Subject: AP1000 COL Response to Requests for Additional Information (TR 3)

## Response to Request For Additional Information (RAI)

RAI Response Number: RAI-TR03-015  
Revision: 1

Figure RAI-TR03-15-1-Strain-iterated shear wave velocity profiles

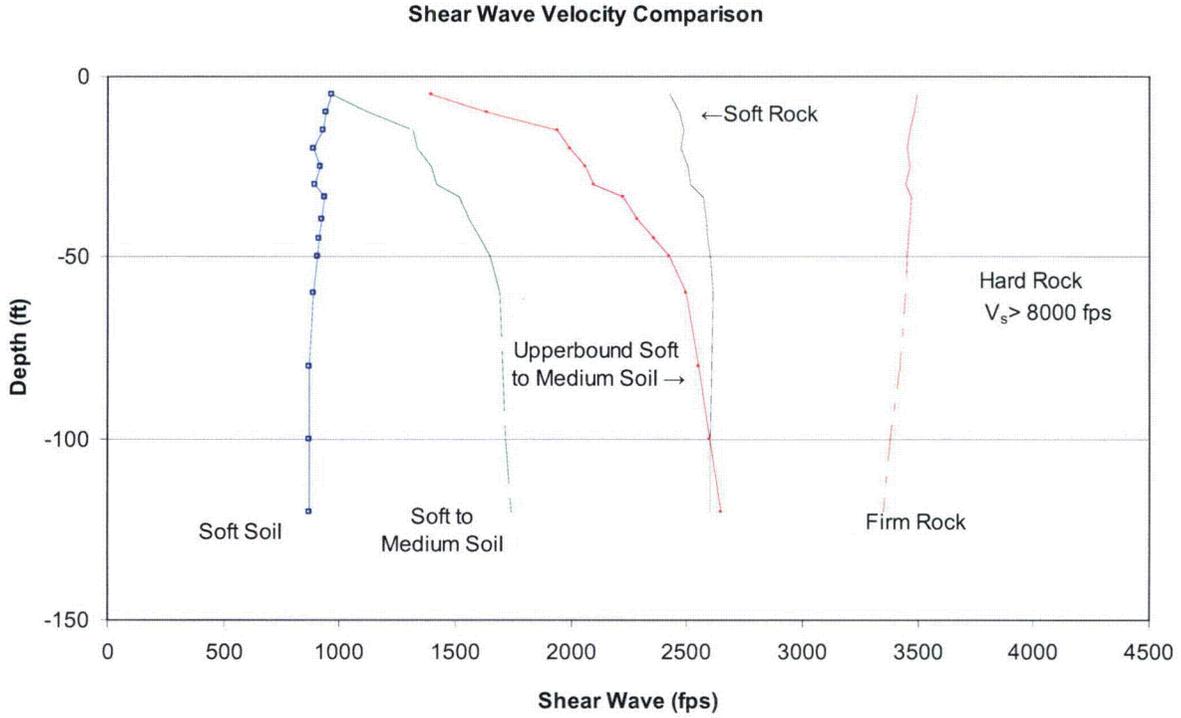
In Page 48 of 154, Westinghouse illustrated that some effects (water table, soil layering, soil degradation model, etc.) are not significant to the seismic response of the nuclear island (NI) structures. Because these results are applied for the AP1000 design, the staff requests Westinghouse provide technical basis for making these conclusions. In addition, Westinghouse needs to demonstrate the combination of these effects is also insignificant to the seismic response of the NI structures.

Westinghouse has addressed soil degradation in RAI-TR03-10. Tables of strain-iterated shear wave velocity used in the generic analyses are shown. Figure RAI-TR03-15-1 shows the bounds of these strain-iterated shear wave velocity profiles. The combination of effects of the different soil parameters is reflected in these bounds. Figure RAI-TR03-15-2 shows how a COL applicant could demonstrate that the site is enveloped by generic seismic design basis. The applicant would define its site geotechnical parameters as defined in DCD Section 2.5 and in a foundation interface report in which the applicant would make its case of why the site is within the bounds of the AP1000 generic analyses that have been considered in this technical report. These parameters would include the soil profiles used in the PSHA analyses, which

could then be compared to Figure RAI-TR03-15-1. Subsequent discussions between the COL applicant and the NRC may uncover a parameter for which more justification is required to show that the impact of this parameter on the response is small. This justification could be done with the AP1000 2D model. An example of how a 2D parametric study would be used is shown in Figure RAI-TR03-15-3 and RAI-TR03-15-4. If the parametric 2D SASSI studies show that the effect could be significant (e.g., 90% of the design spectrum, see Figure RAI-TR03-15-4) when compared to the 2D design spectra, a 3D SASSI study would then be performed. If the 3D SASSI analyses show some exceedances at the critical locations, the applicant would then proceed to show that sufficient margin exists in the design to accommodate these exceedances.

Figure RAI-TR03-022-1-Relative Displacement of Node 3360, top of Shield Building

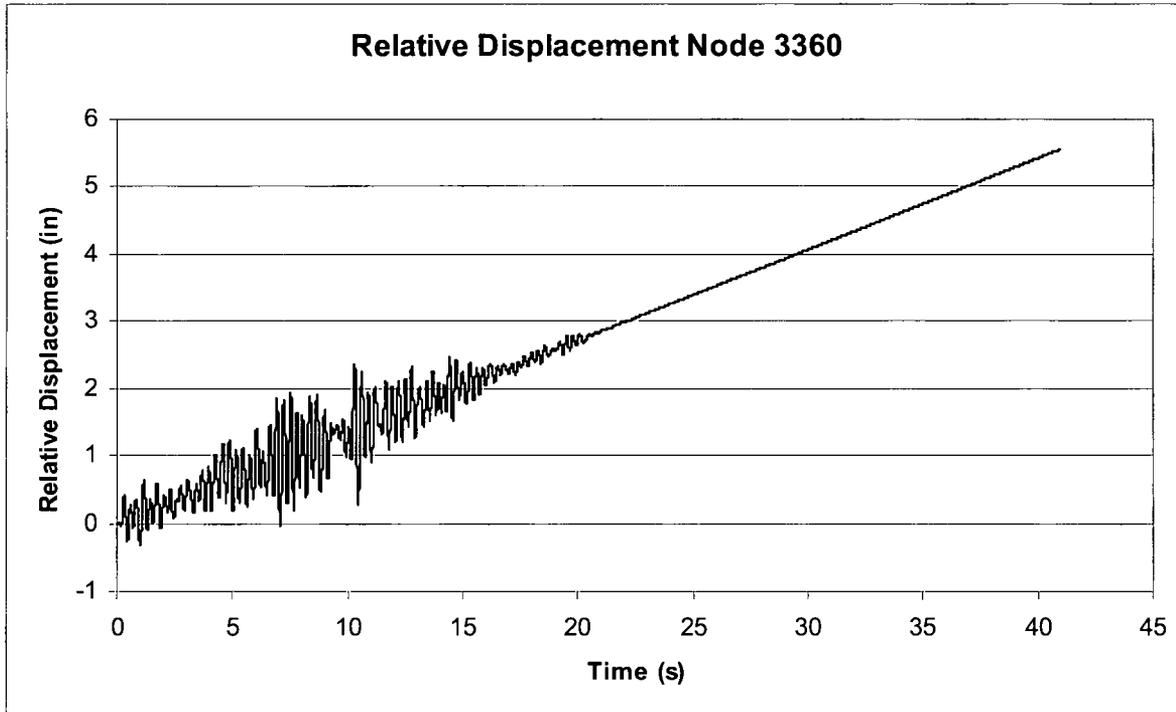
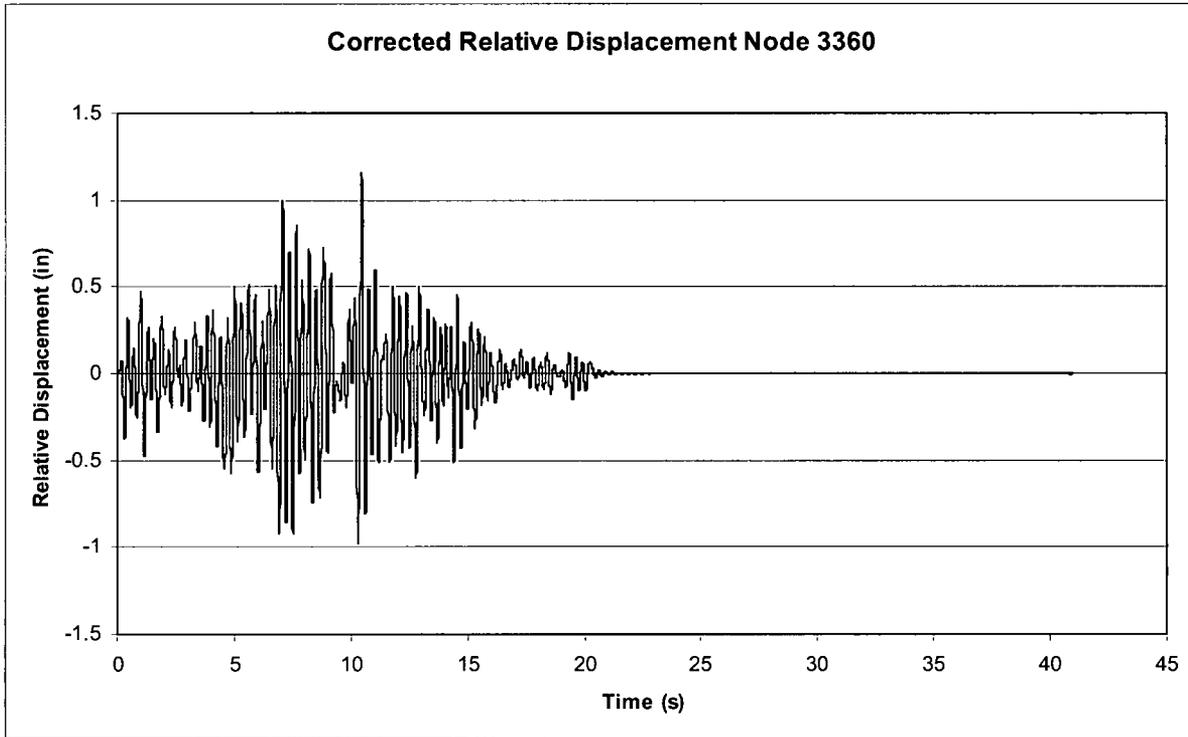
- a. Are the deflections in the tables a consistent set, based on the worst-case time history result, or are they an envelope of maximum deflections from all the time history results?
- b. How do these tabulated deflections compare to the corresponding deflections obtained from the equivalent static acceleration analyses? Please provide a tabulated comparison, and an explanation of any significant differences.

- a. Deflections have been developed using the model with the robust shield building design. These displacements for the soil and hard rock cases have been obtained relative to the translation of a reference node at the bottom of the foundation and near the center of the basemat. Coordinates of this reference node are  $x= 993.00$  ft,  $y= 986.00$  ft and  $z= 60.50$  ft. The deflections have been revised to remove drift. The absolute displacement time histories are calculated from the nodal time histories accelerations. When the relative displacements are plotted there is a constant slope as shown in Figure RAI-TR03-022-1. To correct this drift, the slope of the relative displacement multiplied by the time is subtracted from the relative displacement at each time step. Presented in Figure RAI-TR03-022-2 is the drift corrected relative displacement.

Figure RAI-TR03-032-1 — FRS Comparison at Base of SCV on CIS at RPV Center

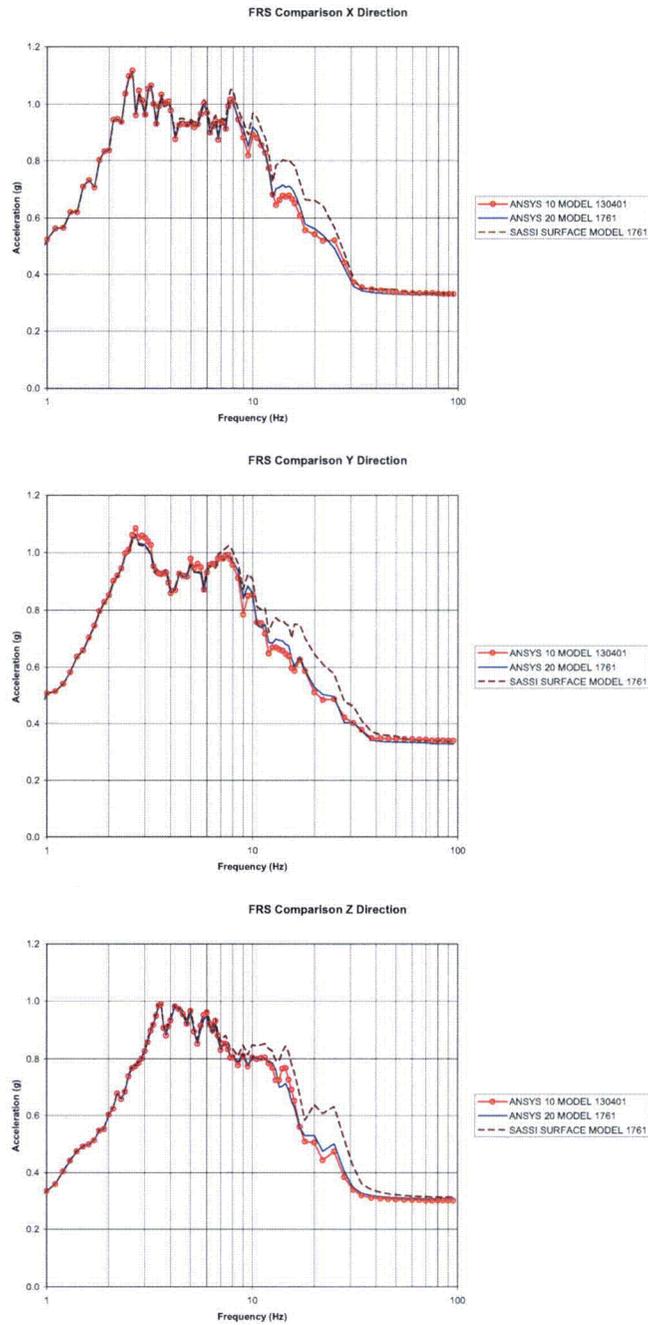
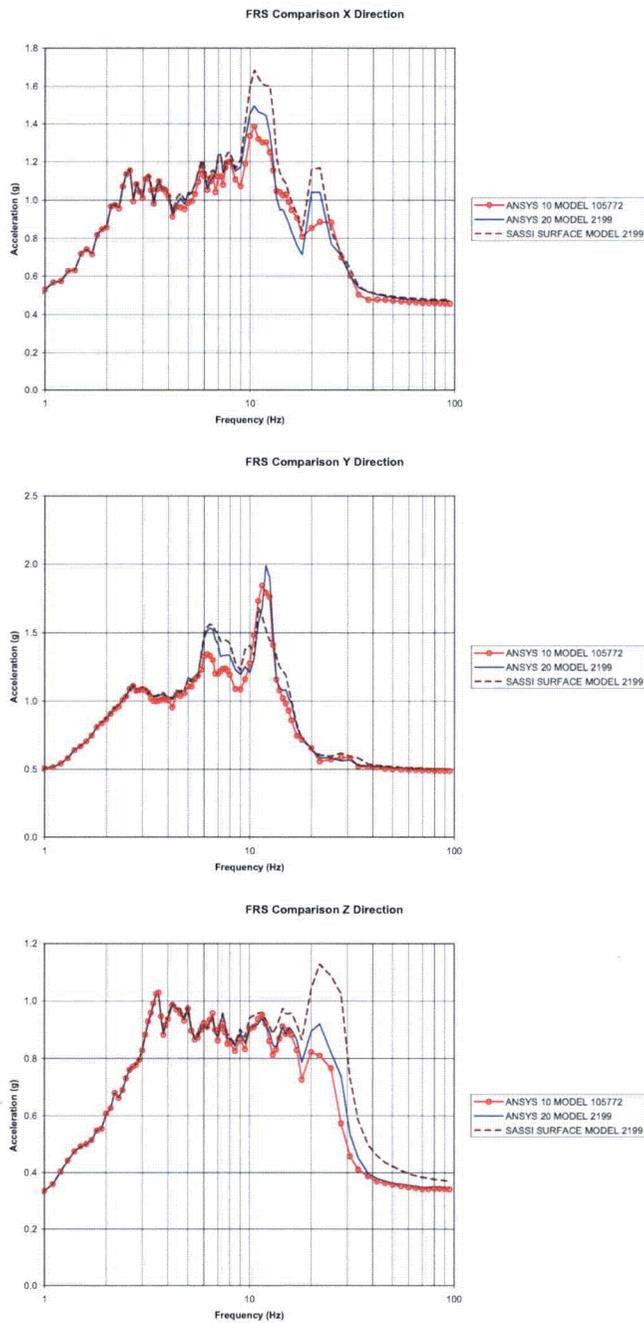
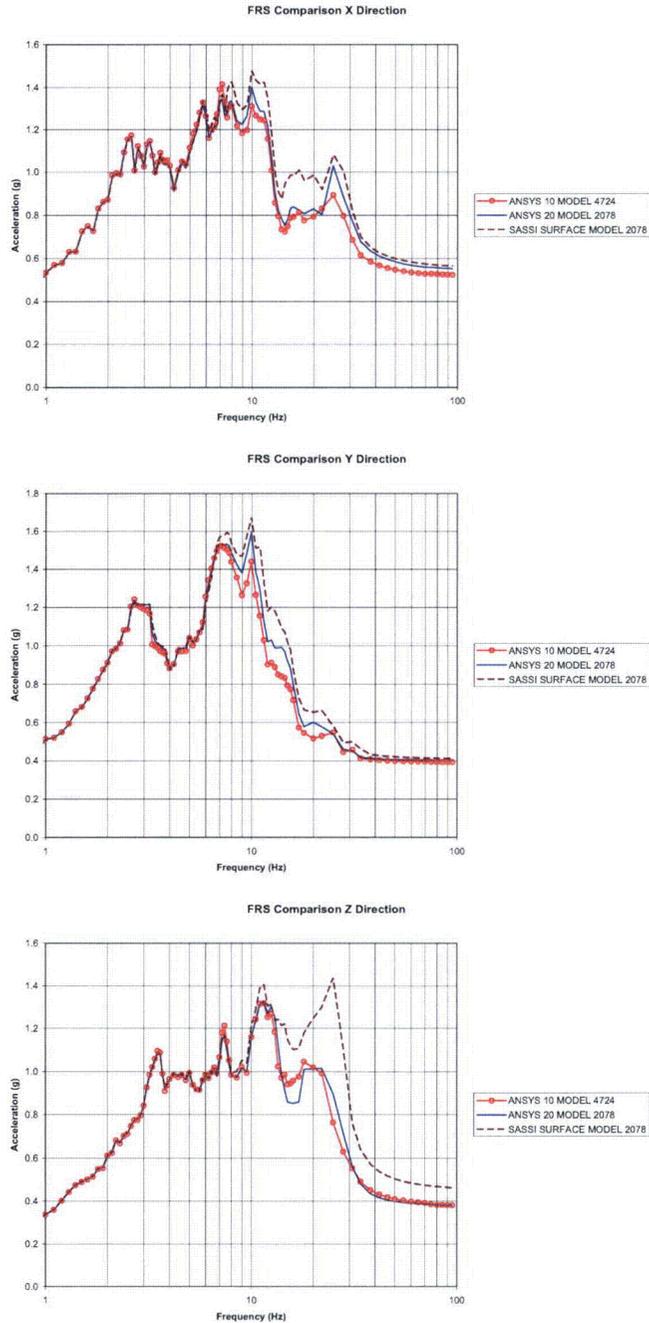
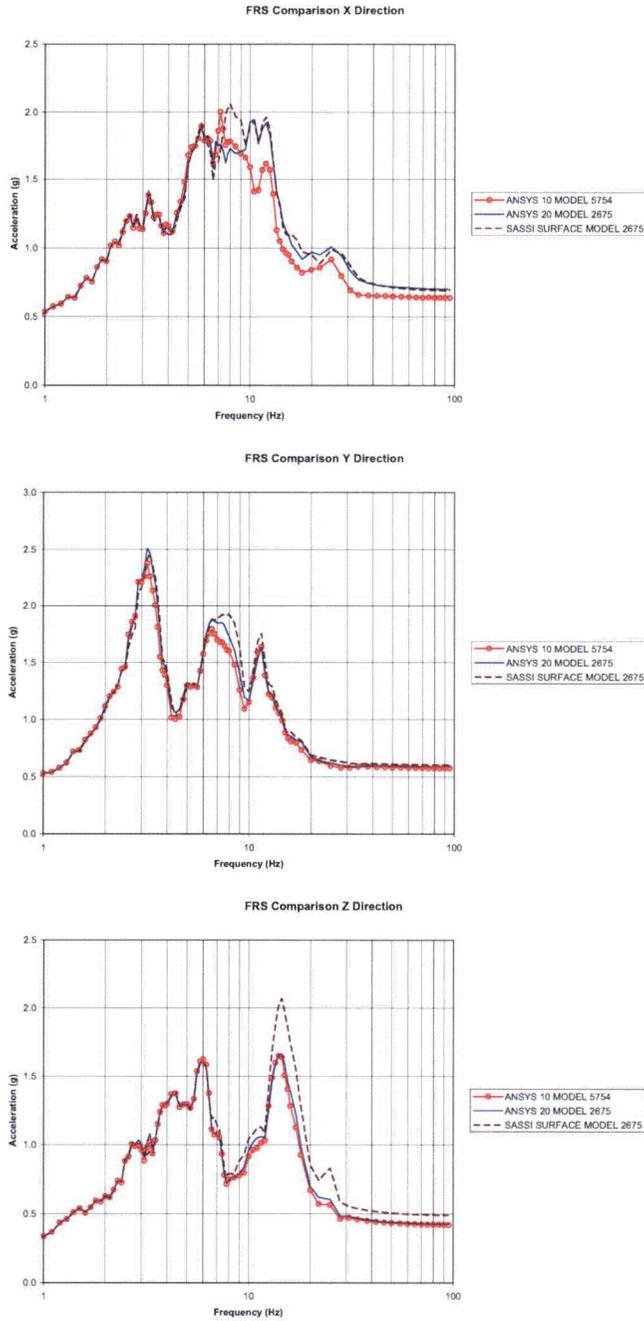
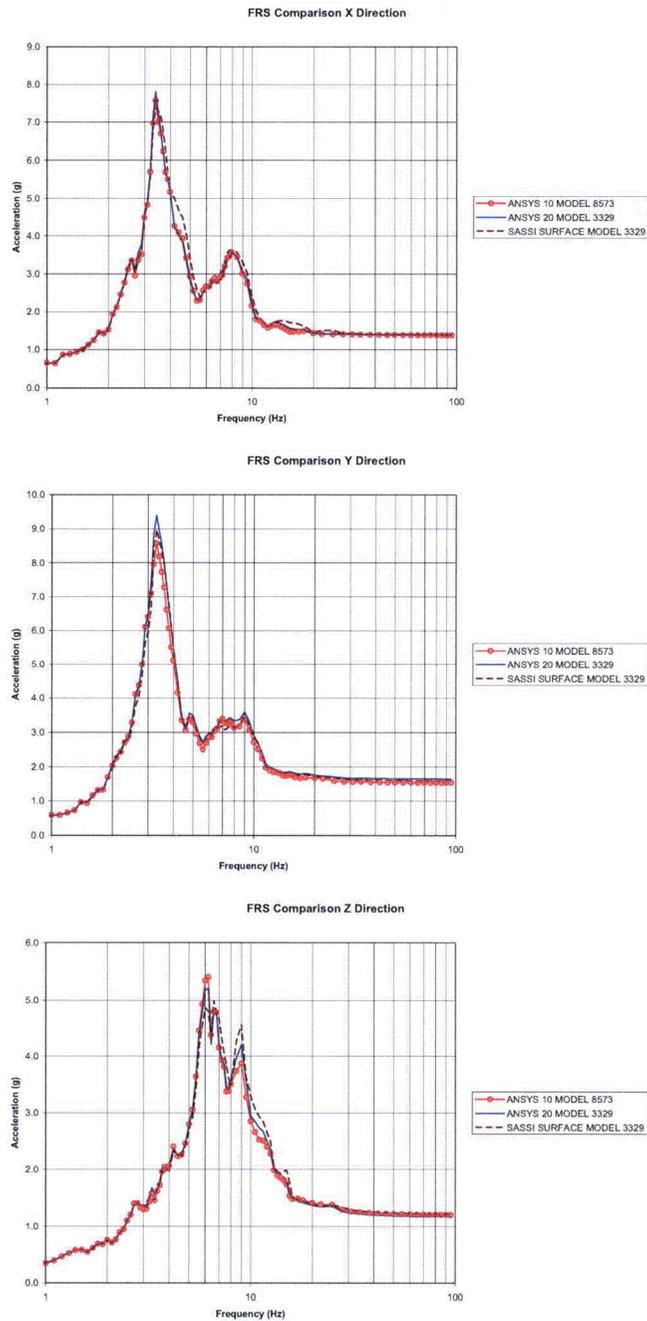
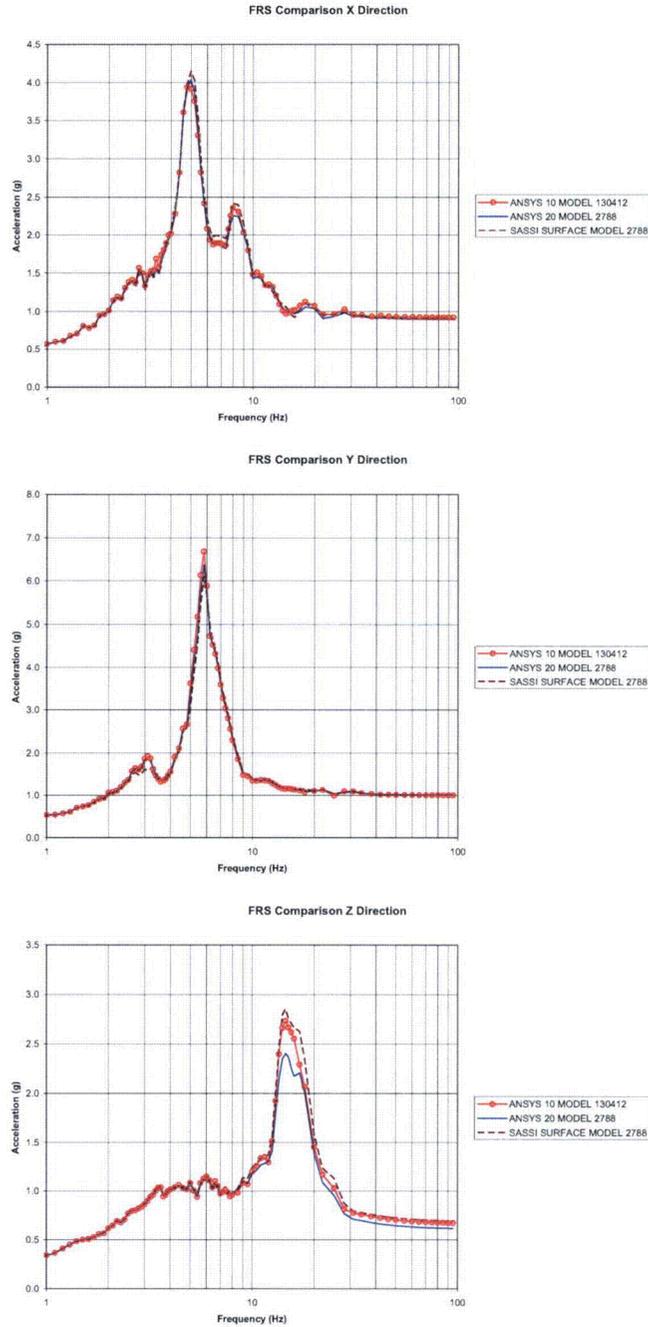
- c. Explain what studies were performed to establish that the NI10 model refinement is sufficient to accurately account for high frequency response effects at all critical locations. It is not obvious from the results shown in Figure C-1 that convergence with element size has been achieved.

- c) The NI10 model is described in DCD subsection 3.7.2 (Item 5) and is the basis for the vertical floor response spectra for hard rock. The model was reviewed and accepted as part of the hard rock design certification. During development of the model detail studies with greater element refinement were performed for the floor above the control room and the adjacent bays to confirm the adequacy of the model.

Location	NI10 Node	NI20 Sassi	Figure ANSYS & SASSI FRS Comparison	General Area	Elevation (feet)
CIS at Reactor Vessel Support Elevation	130401	1761	RAI-TR03-032-1	RPV Center	100.00
CIS at Operating Deck	105772	2199	RAI-TR03-032-2	SG West compartment, NE	134.25
ASB NE Corner at Control Room FloorCeiling	4724	2078	RAI-TR03-032-3	NE Corner	116.50
ASB Corner of Fuel Building Roof at Shield Building	57454	2675	RAI-TR03-032-4	NW Corner of Fuel Bldg	179.19
ASB Shield Building Roof Area	8573	3329	RAI-TR03-032-5	South side of Shield Bldg	327.40
SCV Near Polar Crane	130412	2788	RAI-TR03-032-6	SCV Stick Model	224.00
